Re: S/D 86-33 - Preliminary Plat of Barnes' Cottonwood
Creek Addition.

Re: Final Plat S/D 86-33 - BARNES' COTTONWOOD CREEK ADDITION

STAFF REPORT
(Final Plat; Preliminary Approved 4/10/86)

CASE NUMBER: S/D 86-33 - BARNES' COTTONWOOD CREEK ADDITION
OWNER/APPLICANT: Robert D. Barnes, 2403 W. Douglas, Wichita, KS 67213
SURVEYOR/ENGINEER: Terra Tech Land Surveying, Inc.
LOCATION: North of 29th Street North, in an area between Oliver and Woodlawn.
SITE SIZE: 3.53 Acres
NUMBER OF LOTS:
Residential: 1
Office:
Commercial:
Industrial:
Total: 1
MINIMUM LOT AREA: 151,810 Sq. Ft.
CURRENT ZONING: "AA"
PROPOSED ZONING: "AA"

VICINITY MAP:

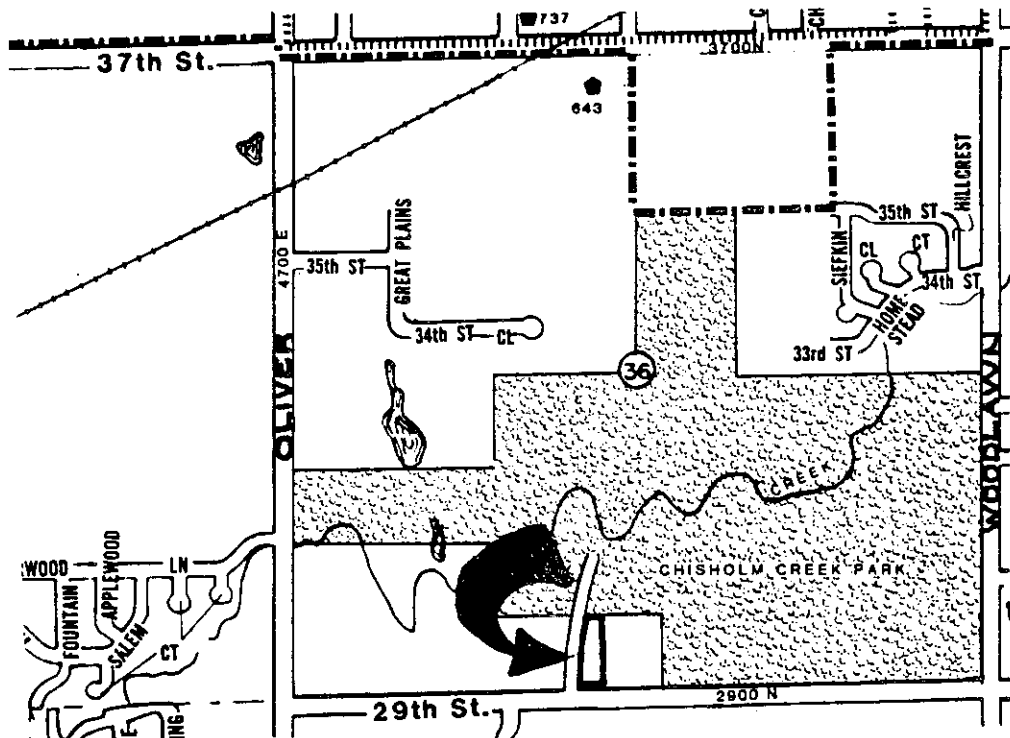
NOTE: The preliminary plat for this subdivision was reviewed in March of 1986. At that time, a primary issue was whether this site, located within the City of Wichita, could or should be allowed to hook-up to a sanitary sewer line which is owned and maintained by the City of Bel Aire.

- A. The applicant shall guarantee the extension of sanitary sewer to serve this property. This requirement was established when the preliminary plat was reviewed. The City Engineer's representative should be prepared to verify if this requirement is still needed.

- B. The applicant shall guarantee any drainage improvements required by the platting of this property.
- C. If improvements are guaranteed by petition, a notarized certificate listing the petitions shall be submitted to the Planning Department for recording.

- D. On the final plat tracing, the perimeter of the floodway being platted shall be dimensioned from all lot corners (i.e., northwest and northeast corners).

- E. On the final plat tracing, the existing sanitary sewer easement on this property shall be dimensioned from the south line of the plat.
- F. On the final plat tracing, the minimum building pad elevation shall also be shown on the face of the plat. Typically this is noted under the north arrow and legend.

- G. As this property is establishing minimum building pad elevations, the face of the plat shall reference the location and elevation of permanent on-site and off-site benchmarks. Section 5-402(N).

- H. When the preliminary plat was reviewed, the Subdivision Committee went on record as recommending the waiver of the lot depth to width ratio of the Subdivision Regulations. 7-204(C).

- I. The applicant shall install or guarantee the installation of all utilities and facilities which are applicable and described in Article 8 of the MAPC Subdivision Regulations.

- J. Perimeter closure computations shall be submitted with the final plat tracing. Section 5-101(C).
- K. Recording of the plat within 30 days after approval by the City Council.

- L. The representative from City Engineering should be prepared to comment on the status of the applicant's drainage plan. City Engineering should also indicate if sanitary sewer needs to be guaranteed for this site or if use of the Bel Aire line is acceptable. The need for any additional easements should also be noted.
